Zion Nuclear Power Station, Units 1 and 2
Facility Operating License Nos. DPR-39 and DPR-48
NRC Docket Nos. 50-295 and 50-304

Subject: Revised Response to Request for Additional Information Related to Partial Site Release and Recent Site Survey Activities

**Revised Response to Request for Additional Information Related to
Partial Site Release and Recent Site Survey Activities**

Figure 3 – Sacrificial Soil Boundary

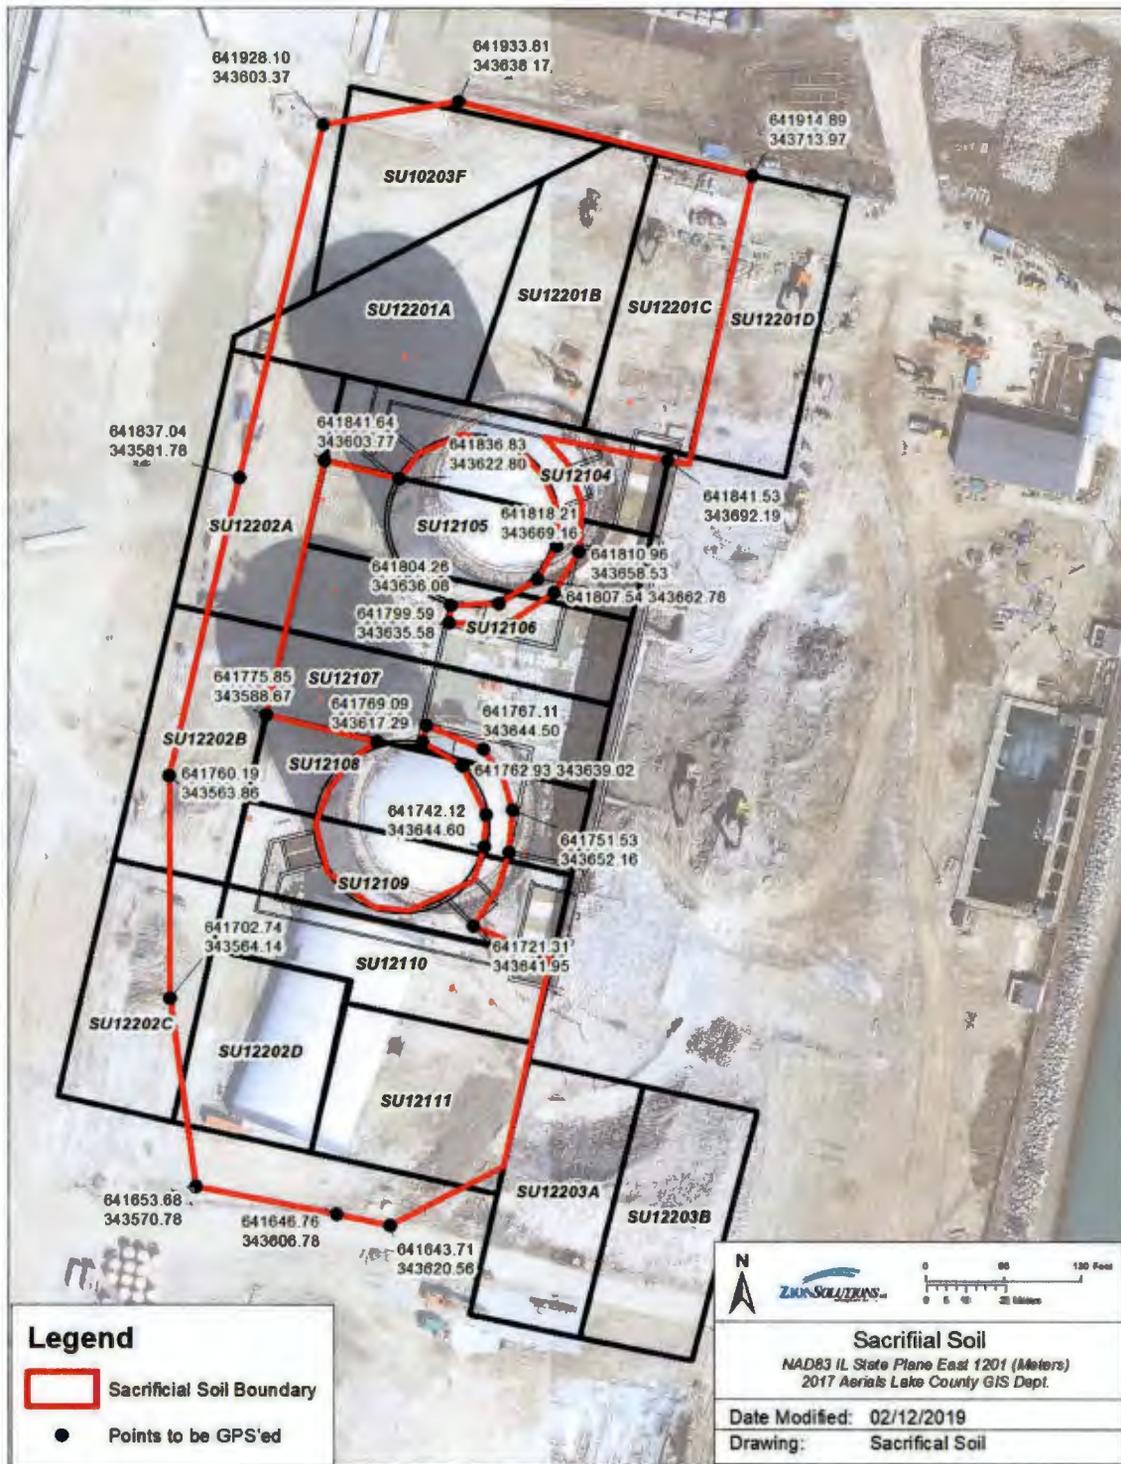
Provide information on whether the material on the Zion site surface is demolition debris that should have been removed during decommissioning, offsite gravel that was used for grading, or some other explanation for its presence, such as basement fill that has been disturbed by action of weather (e.g., erosion, freeze-thaw cycles) or site operations.

Prior to the demolition of the Unit 1 and Unit 2 Containment Buildings, an approximate 1.5 feet layer of sacrificial soil was placed in the areas identified in Figure 3 below. The sacrificial layer was comprised of the clay-like material from the Zion landfill. After demolition of the Containment Buildings, the sacrificial layer was removed in its entirety and any soil beneath the sacrificial layer that had residual radioactivity above the OpDCGL was remediated as necessary. This remediation potentially took soil away from the minimum 3-foot thick fill layers within the footprint of previously-backfilled structures.

A large-scale RA was performed over the entire power block area, and the results were previously presented in the February 10, 2021, submittal ("Power Block RA Report Attachments"). In order to bring these areas back to grade level, in the instance that remediation necessitated the removal of soil below grade, sand was brought on-site from the Antioch quarry. The thickness of the clean cover material intended for the end state over these areas is 3 feet.

The survey units that were impacted by the sacrificial layer of soil and subsequent potential remediation are as follows: 10203F, 12201A, 12201B, 12201C, 12202A, 12202B, 12202C, 12202D, 12202E, 12202F, 12104, 12105, 12106, 12107, 12108, 12109, 12110, 12111.

Figure 5 – Unit 2 Area Grade Measurement Locations

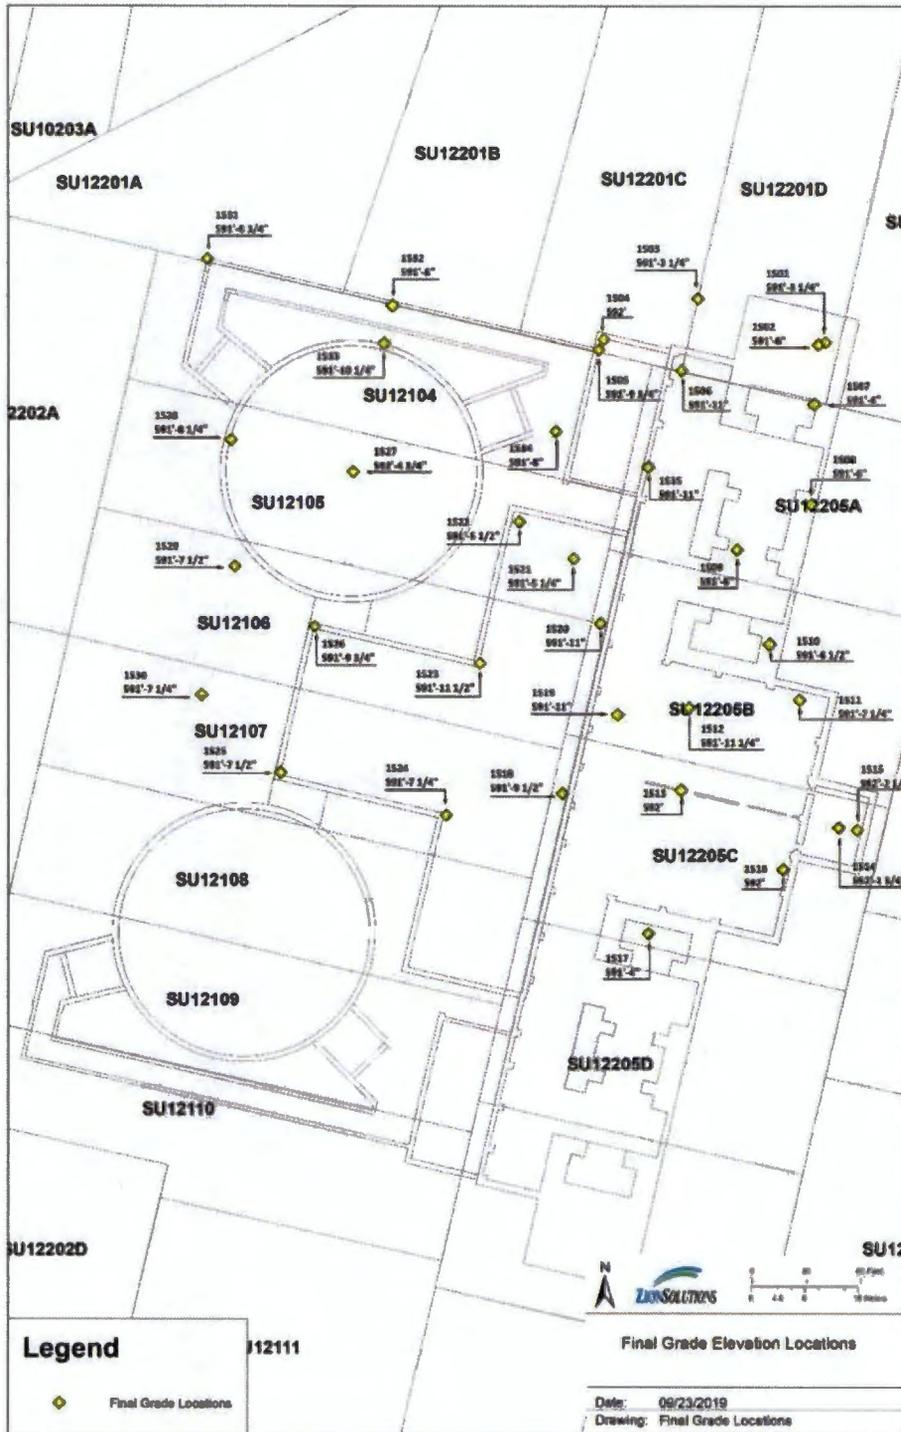
For the areas of the site directly above backfilled basement structures (including the ZNPS Crib House basement in SU 12204), verify that the thickness of the clean cover material between the land surface and the upper level of the basement fill material is consistent with the Zion LTP commitments and the description of the site end state in Phase 4 of the Zion FSSR.

The basements were backfilled using CCDD or clean soil from the Zion landfill. The Zion landfill was tested and approved as an uncontaminated off-site soil source. The final three feet of fill from the 588 feet elevation up to grade (591 feet elevation) consisted of clean soil from the Zion landfill, or as noted in the response to RAI-8a, sand from the Antioch quarry. Final elevation measurements were performed after backfill to verify that the as-left soil elevation was at grade. Figure 4 and Figure 5 below show the as-left soil elevations for the power block area.

As detailed in the response to RAI-1j, final site grading was completed on September 23, 2020. After completion of final site grading, another elevation survey was performed, the result of which is shown in Figure 6. ZionSolutions commits to confirming that final soil elevations are consistent with the LTP. If future observations reveal conditions inconsistent with the assumptions made in the LTP, ZionSolutions commits to making any modifications necessary.
